Daimler Trucks North America
Dale Elder
RSM SE Region
Field Service

Subject: Detroit DT12 Split Rod Bushing Repair

SUBJECT: **Detroit™ DT12™ Split Rod Bushing Repair**

Note: This document supersedes Technical Service Letter 16 TS-22.

Figure 1 – New Steel Bushing and Split Rod

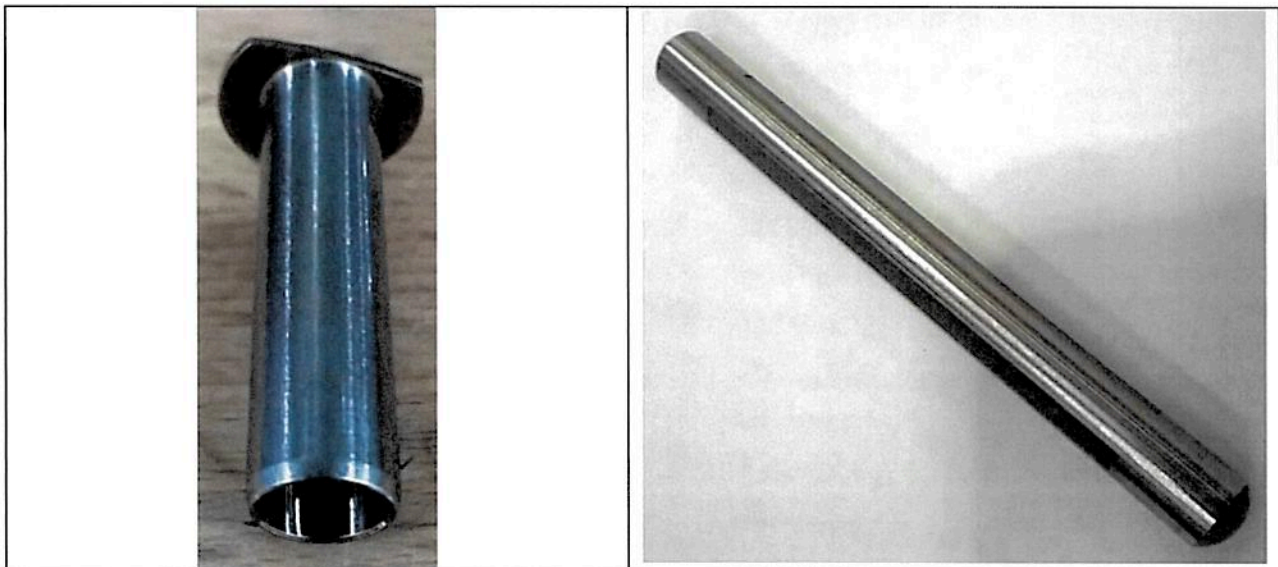
The steel split rod wears on the aluminum transmission housing, causing the split rod to stick. The Shift Controller cannot read the correct position of the split rod and will not shift into gear. To correct this, a hardened steel bushing and new design split rod with three flattened sides were implemented with transmissions built in August, 2016. For Detroit-built transmissions (transmission serial number beginning with 716), the change took place on August 9, 2016, with approximate transmission serial number 716310E0008107. For German-built transmissions (transmission serial number beginning with 715), the change took place on August 29, 2016, with approximate transmission serial number (last seven digits) 1806530. See Figure 1 for the new bushing and split rod.
